Application for Licence

Licence Number	L9272/2020/1
Applicant	Water Corporation
File Number	DER2020/000481
Premises	Dardanup Wastewater Treatment Plant Banksia Road DARDANUP WA 6236 Legal description Lot 20 on Deposited Plan 100642 Part of Lot 82 on Deposited Plan 403943
Date of Report	19 August 2021
Proposed Decision	Licence granted

Figure 1: Dardanup WWTP schematic

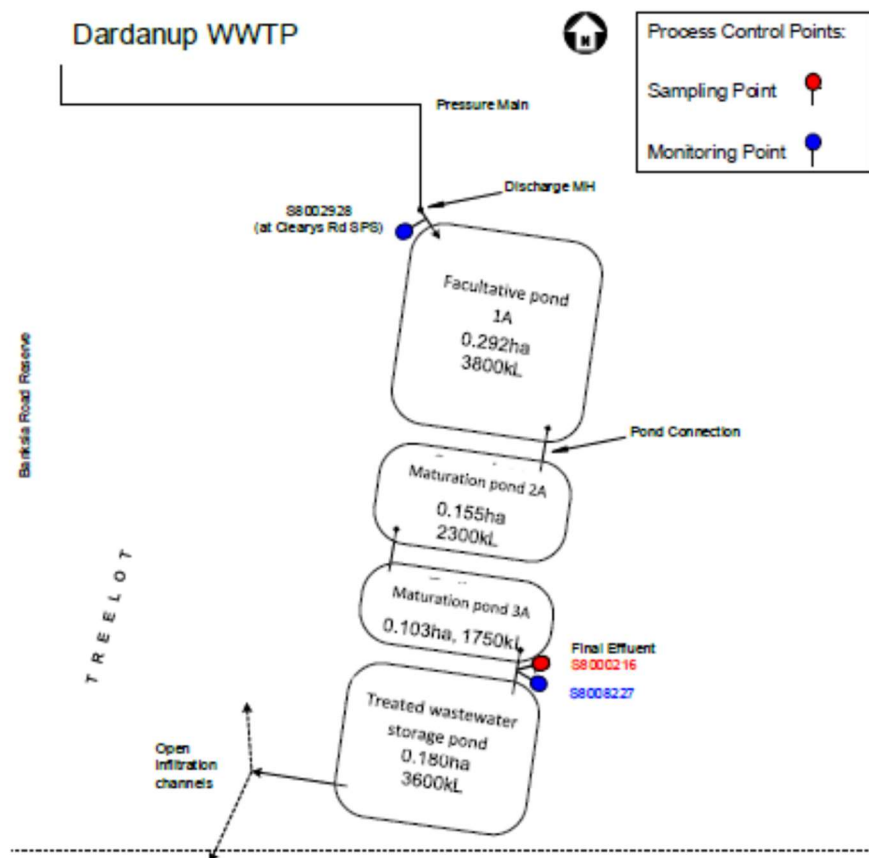
Condition 20 Table 10	<p>Delete the requirement for copies of original monitoring reports submitted to the Licence holder by third parties. Within 14 days of receipt from third parties.</p> <p>An apparent overlap in this requirement with Condition 18 Table 9 Condition 9(c) copies of laboratory sample analysis reports.</p> <p>Request to remove condition 20 altogether.</p>	<p>A person who gives or causes to be given information that to his knowledge is false or misleading in a material particular commits an offence under section 112 of the <i>Environmental Protection Act 1986</i>. Given this, the Delegated Officer considers condition 18 is not required.</p> <p>Condition 20 Table 10 is deleted.</p>
Schedule 3 Schematic map	<p>New schematic provided with new inflow meter identifier number S8002928.</p>	<p>Schematic updated.</p> <p>Schematic at figure 1 of this report also update</p>
